Based on w15-0428- 121018 HeERO Comment Resolution EN 16062 - ERTICO - v1 0with add. T4 CR and CR#

Annex C.1:

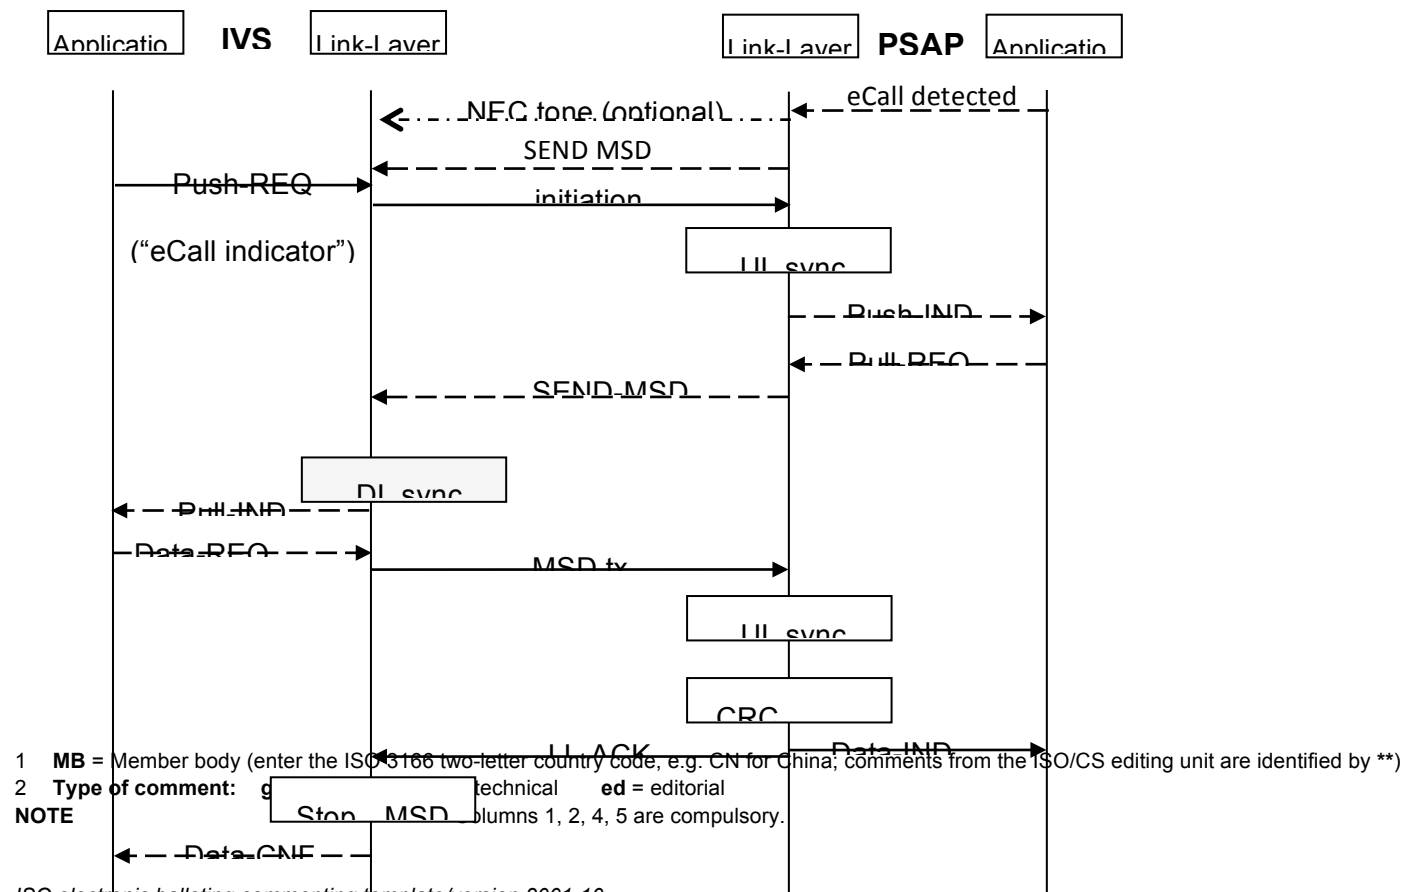
10	7.4.1	Figure 6	ed	See above. Add a clarification concerning the relationship between the EN 16062 SEND-MSD and the TS 126 267 START	Add a note under the figure 6 Note: the SEND-MSD message in this document corresponds to the START message in ETSI TS 126 267.	Editorial clarification
11	7.4.1	Figure 6	te	If the PSAP knows that the incoming call is an eCall, because the eCall indicator has been implemented and used, then the PSAP modem can immediately send the 'SEND MSD' message to the IVS without waiting for the 'INITIATION' message. Waiting for the initiation signal from the IVS adds 2 seconds to the MSD transmission time and increases the amount of time that the PSAP operator and motorist are prevented from engaging in a voice conversation. Reducing the "voice blocking time"	Add the Pull mode procedures in EN 16062 in figure 6: See <u>Annex C.1</u> below	Technical change. Revision required
